FINAL
MONITORING REPORT (MY2)

ALLIANCE HEADWATERS MITIGATION SITE

Response to Monitoring Year 2 (2021) DMS Comments

Alliance Headwaters Stream and Wetland Mitigation Site (DMS #97086)
Neuse River Basin 03020201, Johnston County
Contract No. 6832

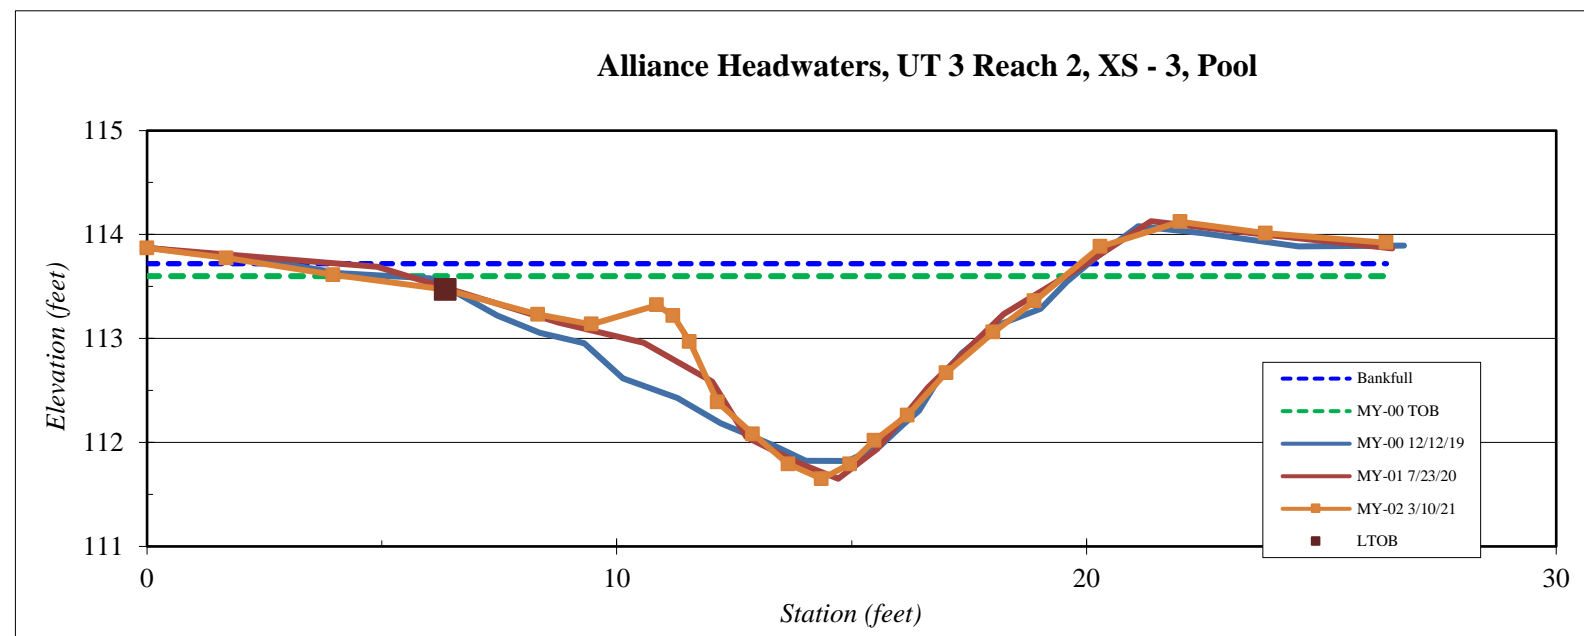
1. Please be sure that BHR is consistently being calculated after the areas outside of the main channel are excluded. For example, UT2-XS1 would only have a BHR of 0.82 if the areas outside of the main channel were included in determining the bankfull elevation that achieves the as built cross sectional area. In other instances (e.g. UT4-XS2) it is clear that those areas outside of the main channel were excluded. Please review these calculations and verify that the same procedure was used throughout.
[All cross-sections were checked and edited if deemed necessary to exclude the areas outside of the channel when calculating bankfull elevation. Cross-section figures and morphology tables were updated accordingly.](#)
